**ARCHITECT'S SUPPLEMENTAL INSTRUCTIONS**

JONES GILLAM RENZ DOCUMENT JGR 710

<b>PROJECT:</b>	The Reserves at Grand View Heights New Development Laramie, Wyoming	<b>Report No.</b>	Eight (8)
<b>OWNER:</b>	Overland Property Group Dan Maximuk 250 N. Santa Fe Ave, Suite A Salina, KS 67401	<b>Date</b>	April 22, 2025
<b>CONTRACTOR:</b>	Overland Construction Group 250 N. Santa Fe Ave, Suite A Salina, KS 67401	<b>Architect's Proj No.</b>	22-3262
		<b>Contract For:</b>	General Construction Mechanical, Electrical

DATE: 7-17-2024  
JOB: 22-3262  
SHEET NO.:

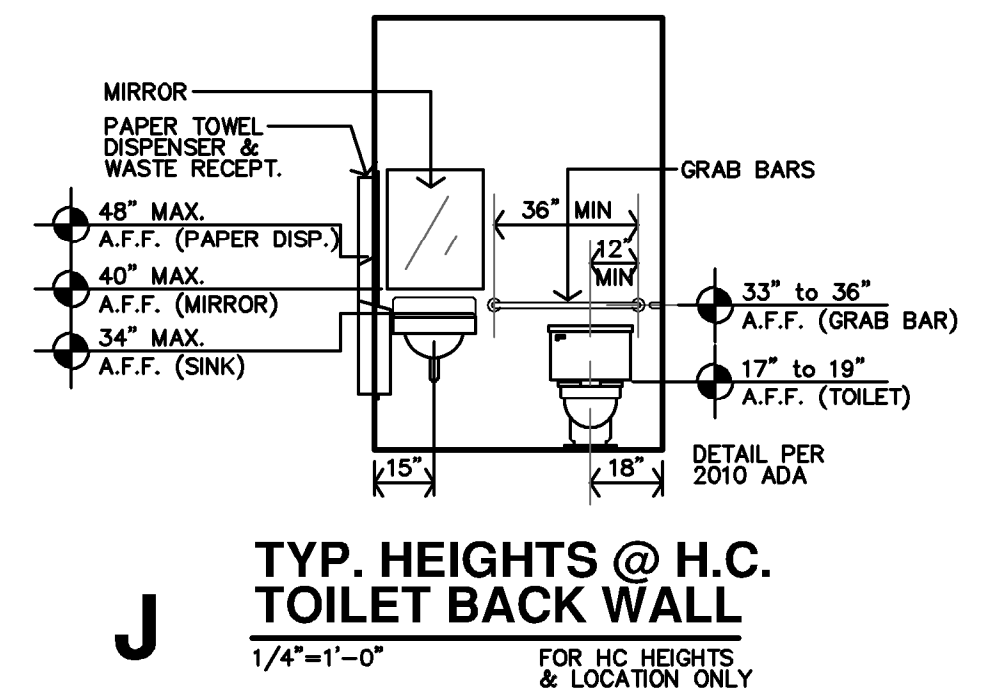
- 1) Sheet A2.11
  - o Detail A – Kitchen sink to have roll-under approach. Cabinet below sink has been removed. Add divider next to dishwasher.
  - o Detail P – Added detail. Add 6" screen below countertop.
- 2) Sheet ME – added ceiling radiation dampers to main supply duct and mech room diffuser
- 3) Sheet P1.1 – revised kitchen sink & lavatory B107
- 4) Sheet P1.3 – revised kitchen sinks in A101 and A102.
